O'Hare International Airport (ORD)
Airspace Case No. 2003-AGL-0848-NRA
Review of Draft Airport Layout Plan

**AERONAUTICAL STUDY
2003-AGL-0848-NRA**

**FEDERAL AVIATION ADMINISTRATION AND
TRANSPORTATION SECURITY ADMINISTRATION**

CONCEPTUAL GRADING AND
 DRAINAGE PLAN FOR FUTURE
 RUNWAY 28C ALSF-2 AND
 RUNWAY 10C LOCALIZER
 O'HARE ALP OPTION 5
 SKETCH LA-1 2/27/03
 TED SMITH FAA ANI-480

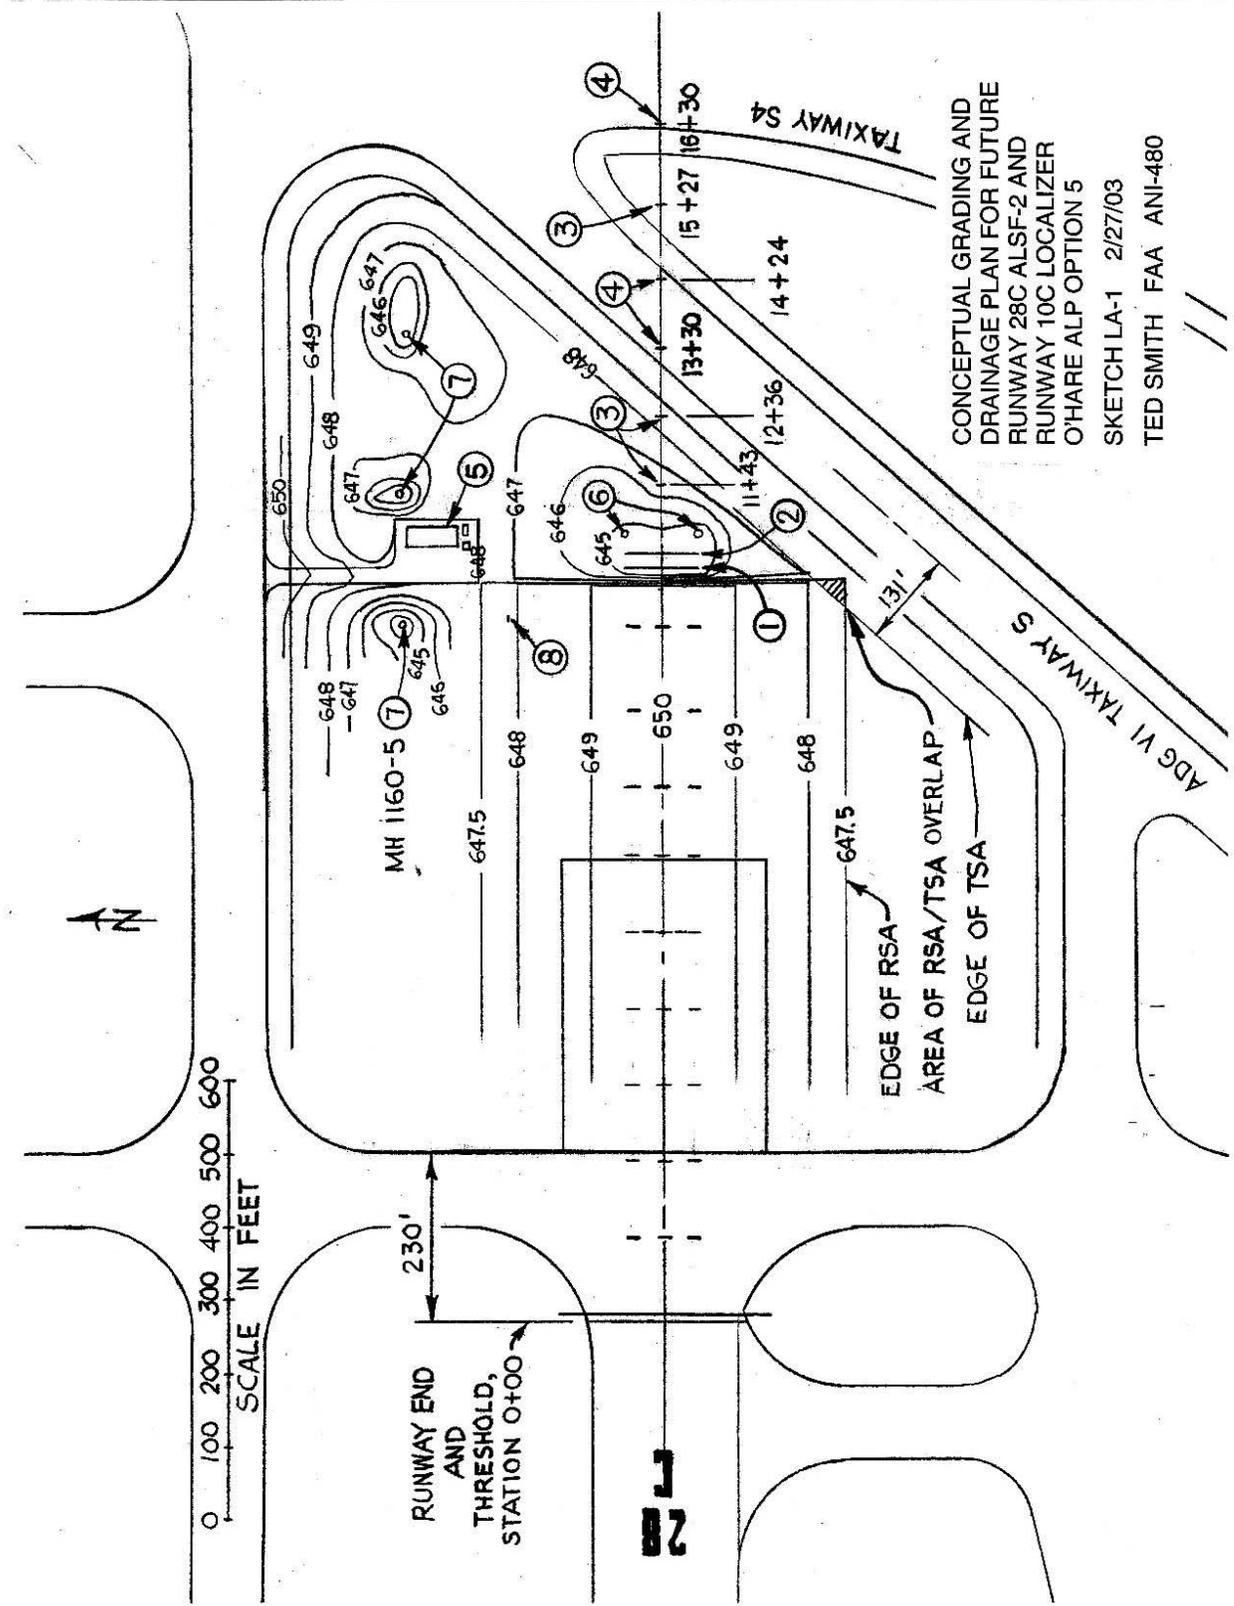
The unusual infield grading proposed in Sketch LA-1 is designed to preclude penetration of the approach light plane by the localizer antenna array. The design was developed because:

The frangible lights near the taxiway and runway edges will have to be as low as feasible, to ensure that they will not be struck by any portion of any airplane, regardless of the airplane's position on the runway. The flasher ICCs will have to be remote from those lights for the same reason. Previous research has revealed that the outboard nacelles of some four-engine jets are low enough to be of concern for low objects mounted a considerable distance from runway and taxiway edge. Because of cable length limits, some ICCs will have to stand within taxiway or runway safety areas, some in OFAs. We anticipate that it will be necessary to cluster three ICCs near station 15+27, on the slightly depressed grade of the infield between stations 14+24 and 16+30. The three ICCs near station 15+27 will be those for the sequenced flashers at stations 14+24, 15+27, and 16+30.

- Two ICCs near station 18+30, serving flashers at 17+30 and 18+30.
- Three ICCs near station 19+30, serving flashers at 19+30, 20+30, and 21+30.

- Three ICCs near station 24+30, serving flashers at 22+30, 23+30, and 24+30.

FIGURE 1-1. GLIDE SLOPE SNOW CLEARANCE AREAS

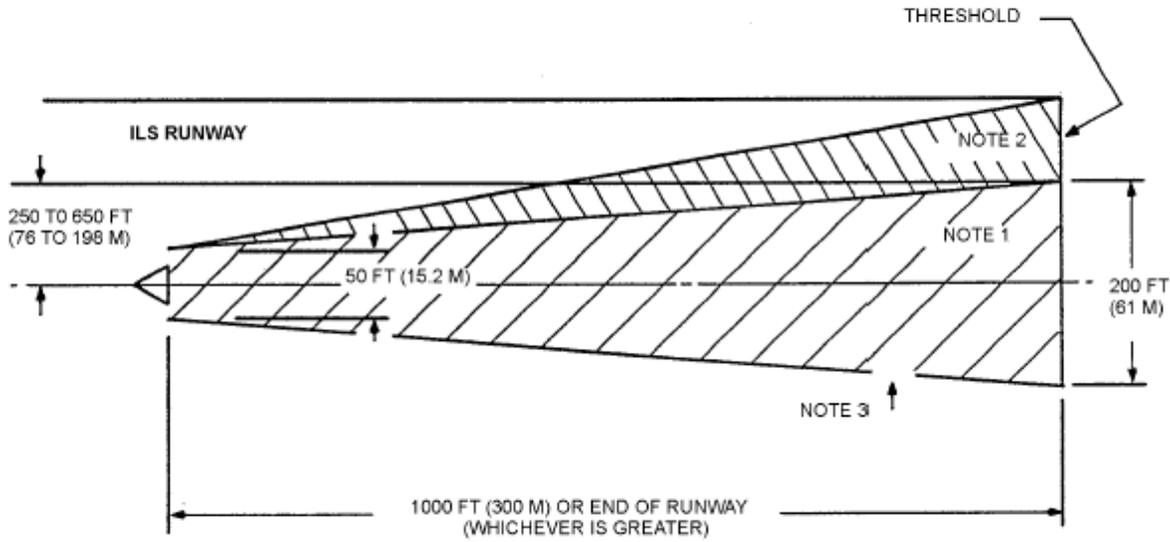
A-17) Glide Slope snow removal areas should be modified to meet standard.

b. Snow Accumulations. If the average snow and ice accumulations in the snow clearance area (see figure 1-1) exceed specified limits of table 5-3, request that minima be raised to "localizer only" until the conditions revert or are corrected.
